MIDWEST POOLED FUND PROGRAM

Progress Report - Second Quarter 2010 April 1st to June 30th

Midwest Roadside Safety Facility
Nebraska Transportation Center
University of Nebraska-Lincoln

August 2, 2010

Figure 1. Curved Rail W-beam Transition

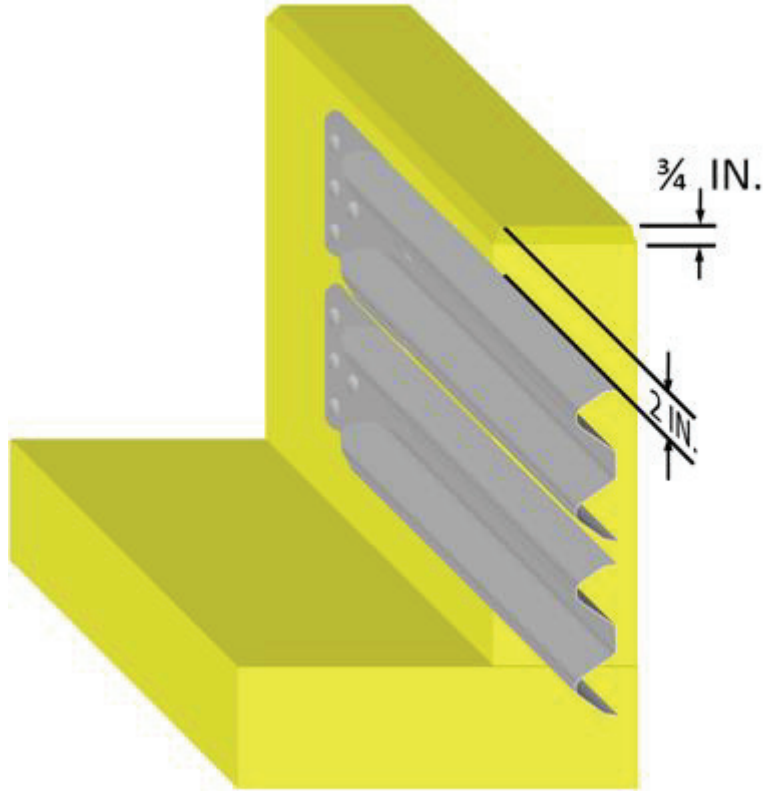
My questions are these. Do you see a snag potential in the as-built condition? If so, is it drastic enough for us to fix it? Grinding the concrete taper is not an option so the only remedy would be to raise the rail: an exercise we don't want to undertake. Of course we will if there is a danger to the public.

Guardrail Clearance Distance

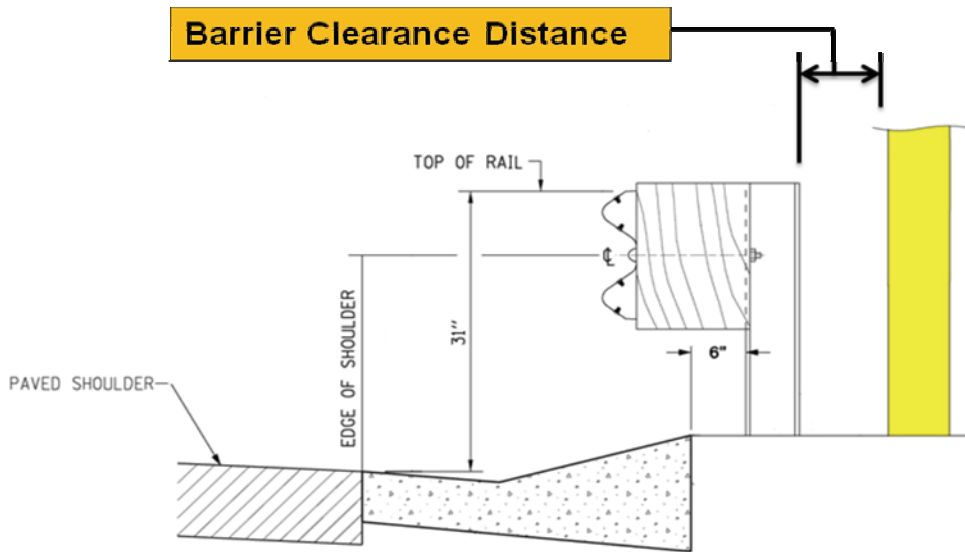
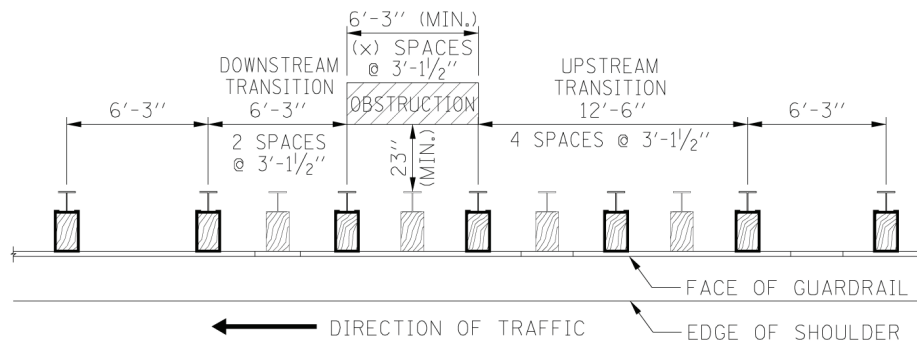
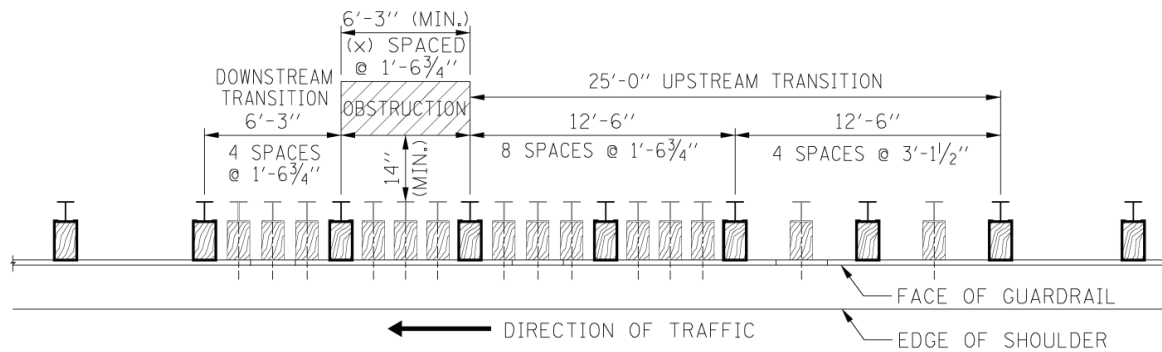
I think this is related to another question that I had a few weeks ago. We are putting together Tollway guardrail guidelines for designers to use. I would like to provide some guidance on conflicts with posts within a run of guardrail. We have some drainage structures that are about 9' across. If one of these drainage structures falls at a post, would it be better to just leave one post (or 2?) out or shuffle the post spacing and use all of the posts. Shifting the posts around would place posts where there are no pre-drilled holes in the rail. Is that an issue?

In locations where existing obstructions cannot be offset further from the roadway to obtain the minimum required guardrail barrier clearance distance, stiffer guardrail transitions shall be accomplished through reduced post spacing. For all new installations, obstructions shall be no closer than the minimum desirable clearance distance. When the minimum design clearance distance is not obtainable, a design deviation shall be submitted to the Tollway's Chief Engineer for consideration.

It is not permissible to leave out any posts. Also, additional block-outs are not to be added to provide a greater offset, in order for the post to avoid an obstruction. Block-outs shall not be omitted. For Type A Guardrail, maximum post spacing shall be 9'-6" and minimum post spacing shall be 3'-0"

To answer your question about the use of CRT posts in the Long-span system – They reduce the affects of vehicle snag on the posts. CRT posts are designed to maintain bending strength about the string axis (laterally) but are substantially weaker about the longitudinal direction. Thus, when a vehicle contacts a CRT post, it will fracture or break away and consequences of vehicle snag are minimized.

Second, in circumstances where the hazard/rail is susceptible to impacts from vehicle traveling in the opposing traffic direction, you would want to make the transition symmetric about the hazard (i.e., change the downstream portion to match the upstream.

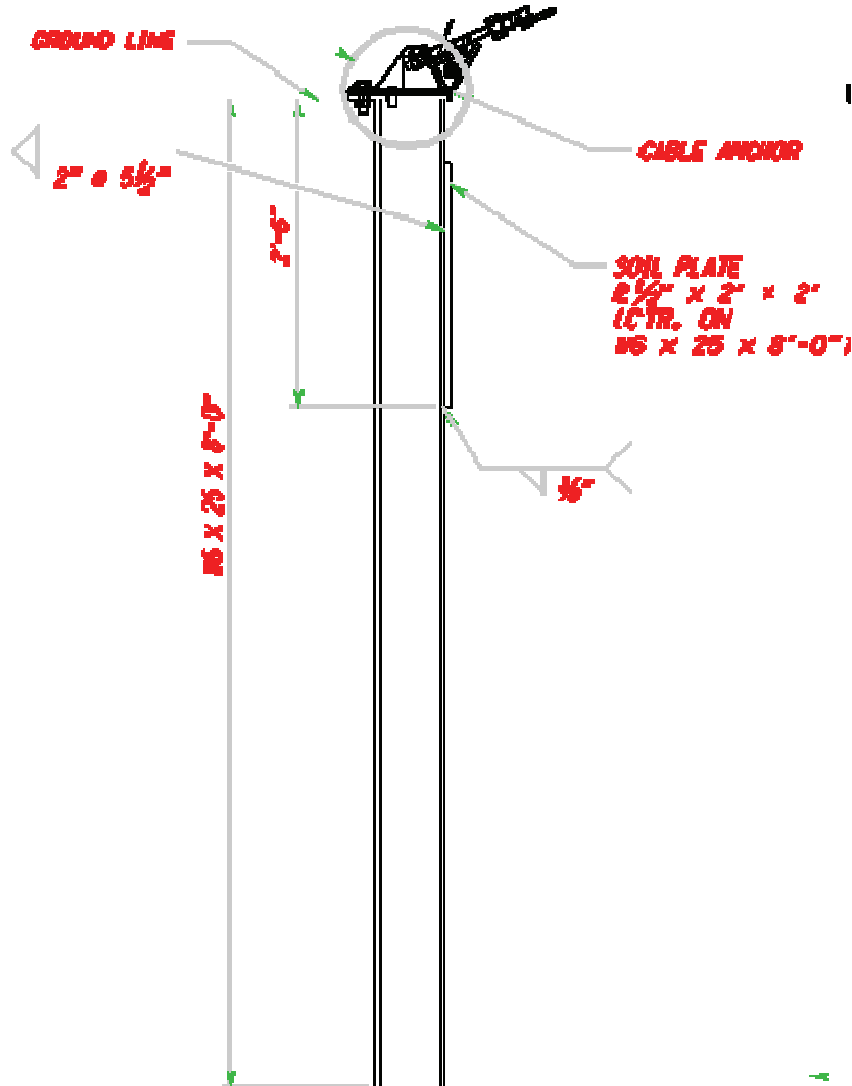
- 1.) Can the soil; plate be bolted to the post after being driven?
The installer would like to drive the post without the soil plate attached.
What size bolts and how many could be used?

2.) Post #2 – the Cable Bracket Detail shows a cut to allow a ¼” x 1.5” piece of metal cut to fold down and hold the cables in place. These break easily sometimes during installation and regularly in a crash.

Are these mainly for installation convenience?

1) Yes the soil plate can be added after the post is driven into the ground. You will have to dig a hole large enough to properly place the plate on the post – note it is 2 ft wide and extends 2.5 ft below the surface. Also, you will need to compact the soil around the post/plate when the hole is filled. Uncompacted soil will not generate the necessary resistance for the anchor. We use a pneumatic tamper and install soil in 8 inch lifts when we compact soil at our test site.

Figure 3. Median Barrier Details

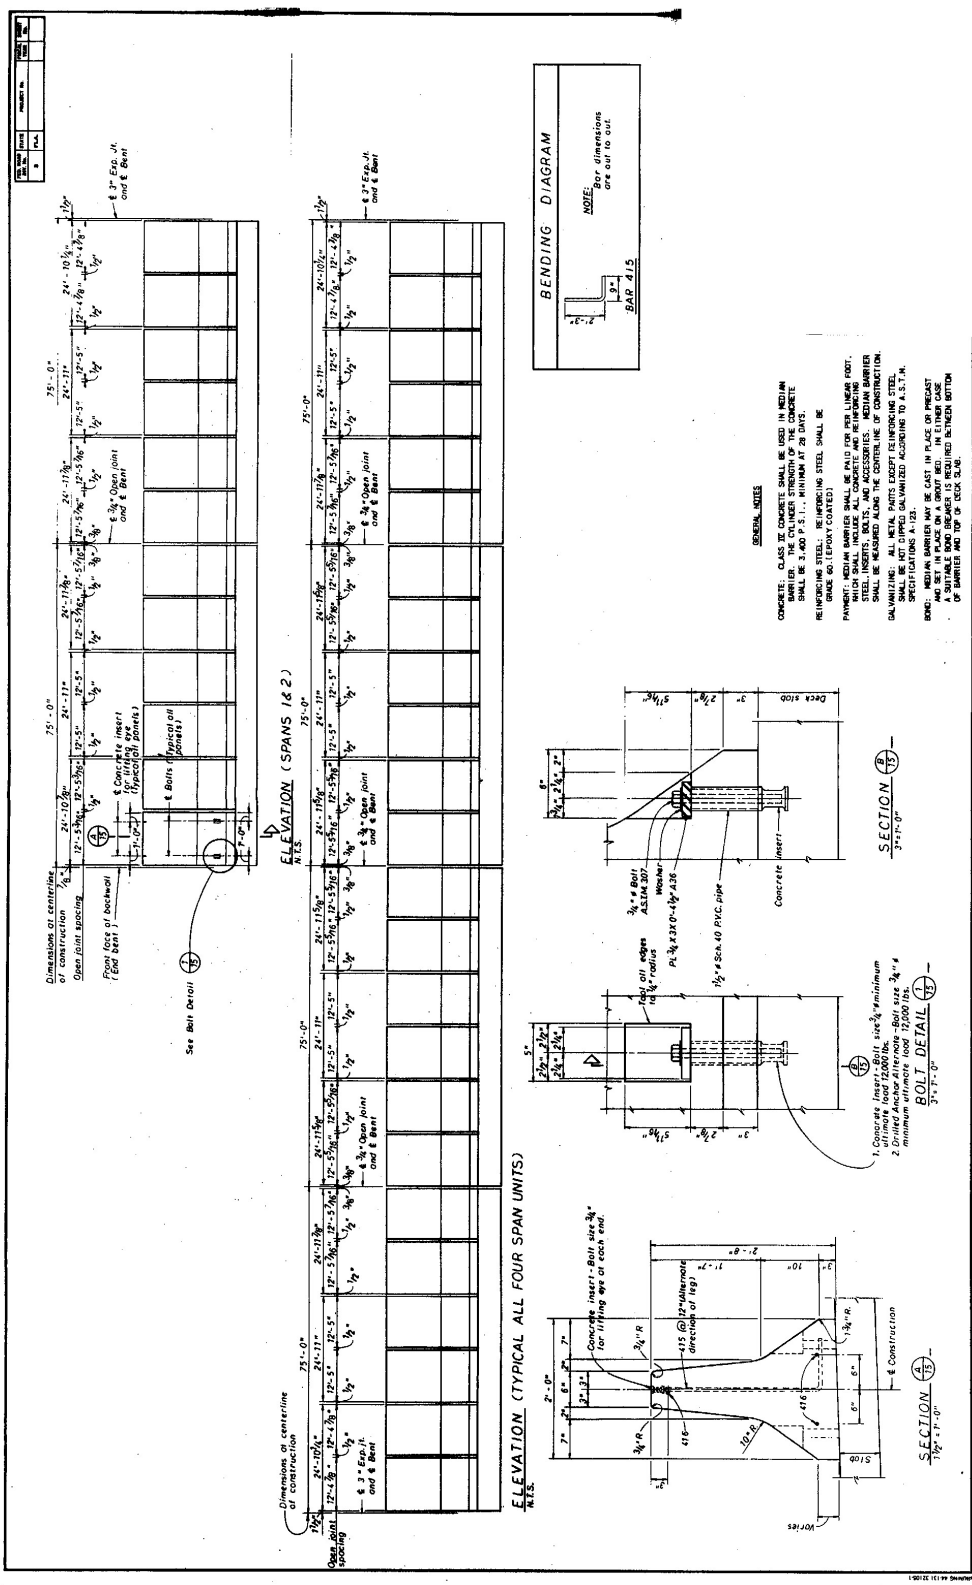
It is difficult to determine from the drawing, but there are three #4 longitudinal bars (one near the top and two near the bottom) shown in "Section A", which is most likely intended to resist lifting and handling stresses. Since the drawing is not to scale, the aspect ratio of the elevation view may be misleading. There are only four anchors per unit (anchors paired transversely, then spaced at +/- 10.5' o.c. longitudinally). Would this affect your opinion?

I have looked over the median barrier detail you sent and I have some concerns with it.

I have not seen a detail like this before. I would not expect this system to pass TL-3 of NCHRP 350 or MASH. There may be some chance of it passing at TL-2, but more analysis would be needed.

Figure 4. Cable to W-Beam Transition

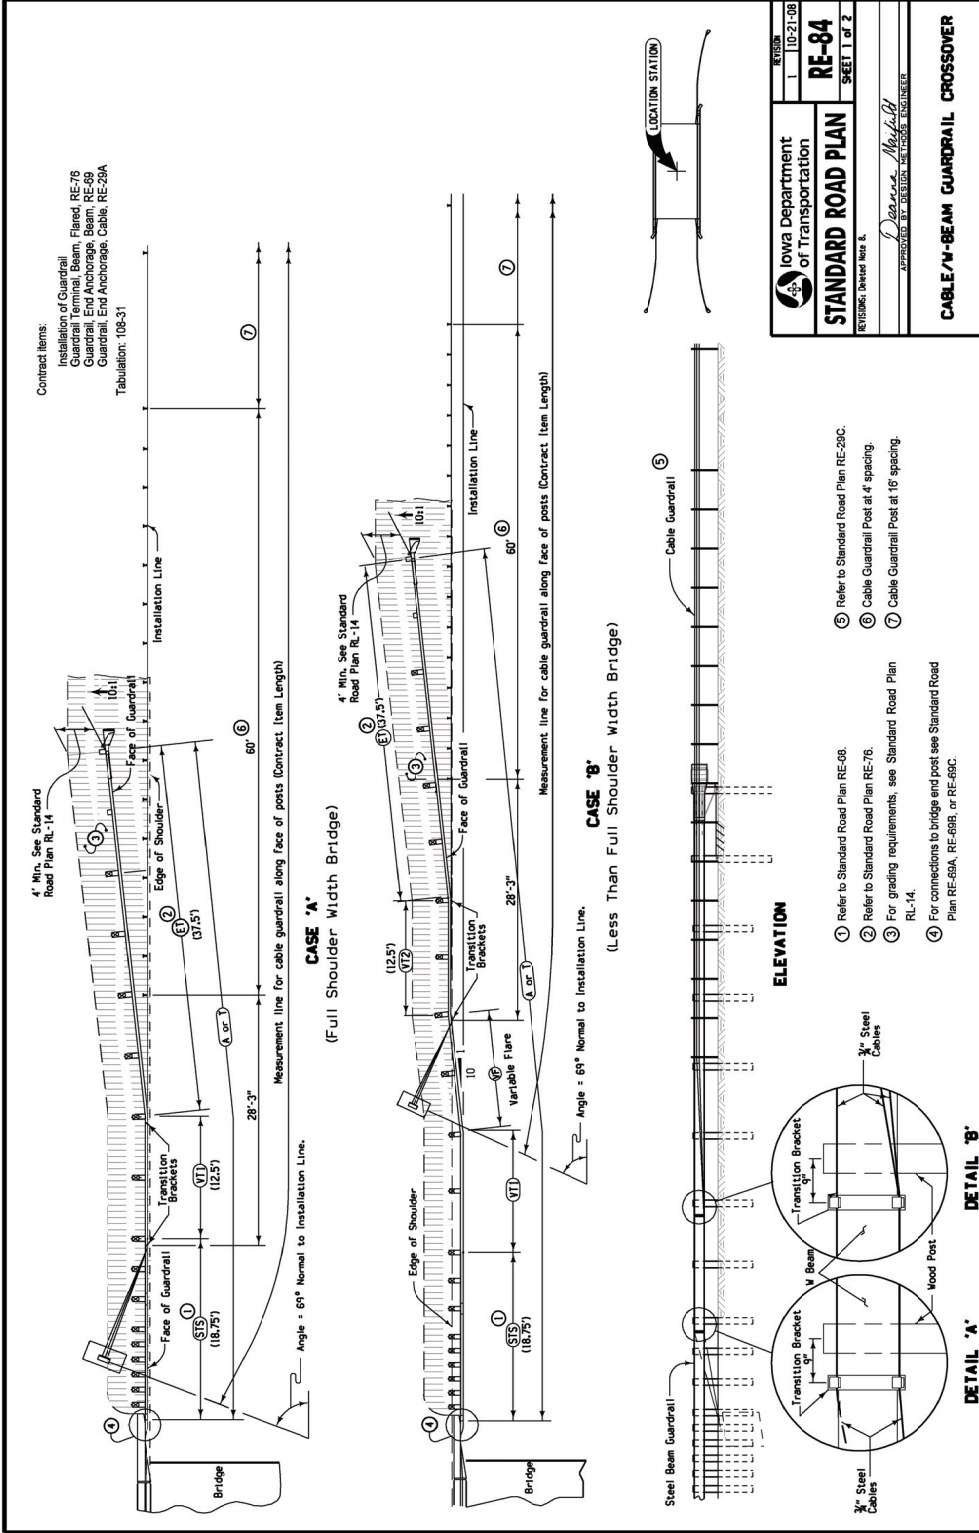
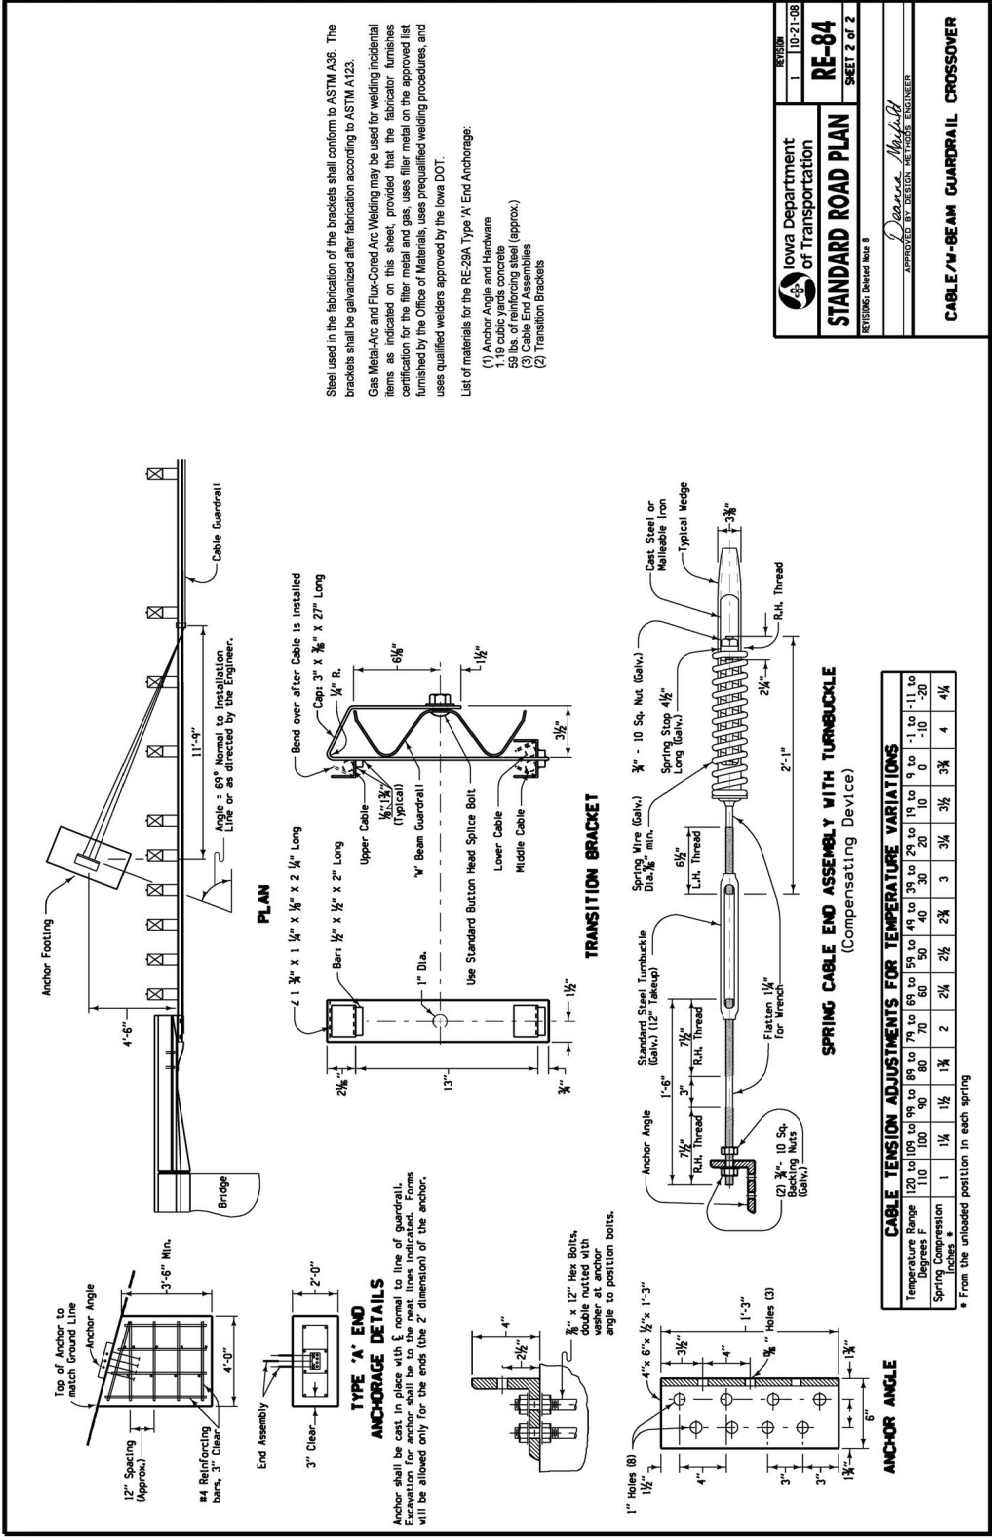
'Case A' on the drawing allows one of the transition brackets to be placed on the w-beam end of the w-to-thrie transition piece. As is clear from the drawing, especially in the plan view on sheet 2, this configuration has proven very difficult to construct; the downstream post and blockout interfere substantially with the path of the cables as they travel from the transition bracket to the end anchor.

In your opinion, should we allow 'kinks' in the cables as they travel around the post and blockout? If not, would we be able to adjust the location of the transition bracket and the end anchor to provide a straight line of travel for the cables?

We have looked at your details and have a few comments and responses to your questions. We looked at several options for Case A in your details.

A total of four solutions were investigated. The first solution consisted of allowing the wire rope to bend around the post at the midpoint between posts at standard spacing. However, analysis of the degree of bending of the wire rope around the posts, in combination with concern that the wire ropes will either lose tension during post deflection or be pulled from the terminal, indicates that this alternative is likely not an acceptable solution without crash testing to prove crashworthiness.

The second solution proposed by the Iowa DOT was to shift the downstream transition bracket further upstream which would decrease the effective angle to the anchor bracket and allowing the cables to bypass bend locations around the post. While this design would help alleviate cable interference with the post, it is not known what the effect of shortening the overlapped cable length would have on the design. Changing the position of the transition bracket would change the angle of the cables to the ground anchor. One of the concerns in the original design of this system was the potential for snag of the vehicle in the area where the cables angle down towards the ground anchor. Thus, I am leery of changing the transitioning of the cables or the location of the anchorage without further analysis.

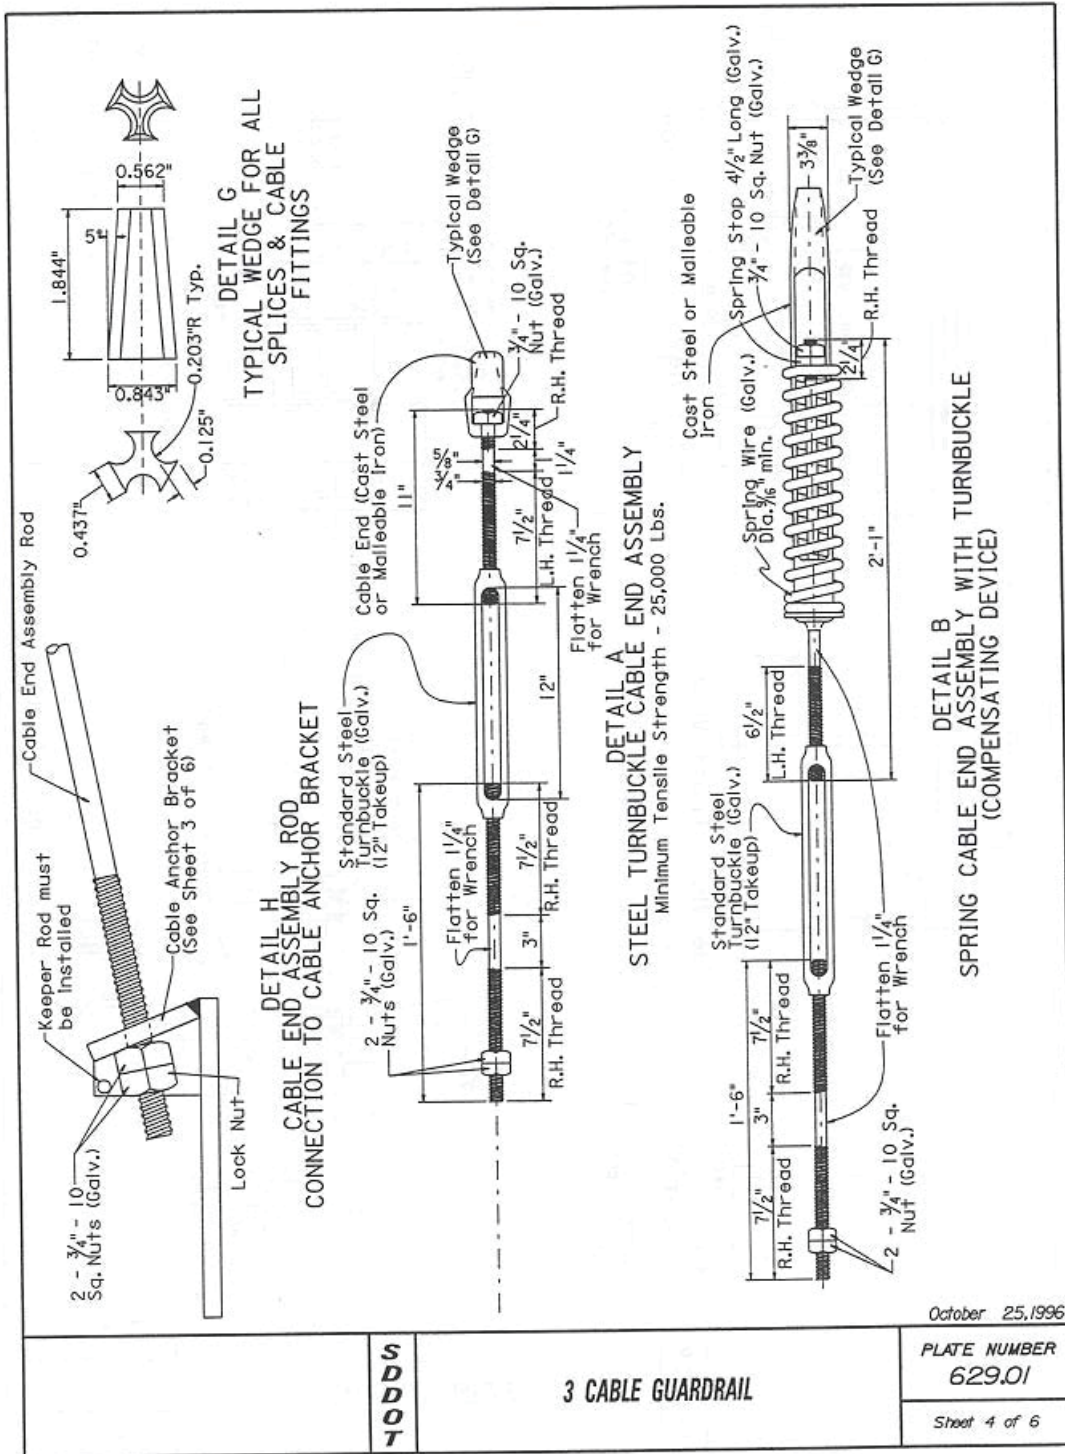
An additional option proposed was to drill a hole in the blockout of the post which interfered with the cables. This design option has several advantages, in that the positioning of the bracket and the W-beam do not change relative to each other, minimizing the potential for snagging, pocketing, and loss of cable tension. However, the required size of the hole required to pass the cable through the blockout would be very large, which could lead to lower compressive strength of the blockout, greater propensity for twisting, and the cables would be subject to post rotation or fracture in the soil. Damage to the post at the point of cable routing could interfere with the cable's tension and could potentially cause catastrophic release of the cable from the end terminal. Furthermore, the additional labor required for field drilling holes in the blockout and the potential to cause unexpected damage are high; therefore this is not an optimal solution.

The final design option is to add an additional 12'-6" of guardrail between the the flared crashworthy end terminal and the approach transition. By introducing an additional span of guardrail, transition bracket interference issues, cable tension concerns, and field operations are maintained. In addition, this options allows the cable transition to be completed before the approach transition to the bridge rail begins. Though this may be the be slightly more expensive option, it is nonetheless the most crashworthy from a design standpoint, and will most likely result in acceptable performance of the transition design.
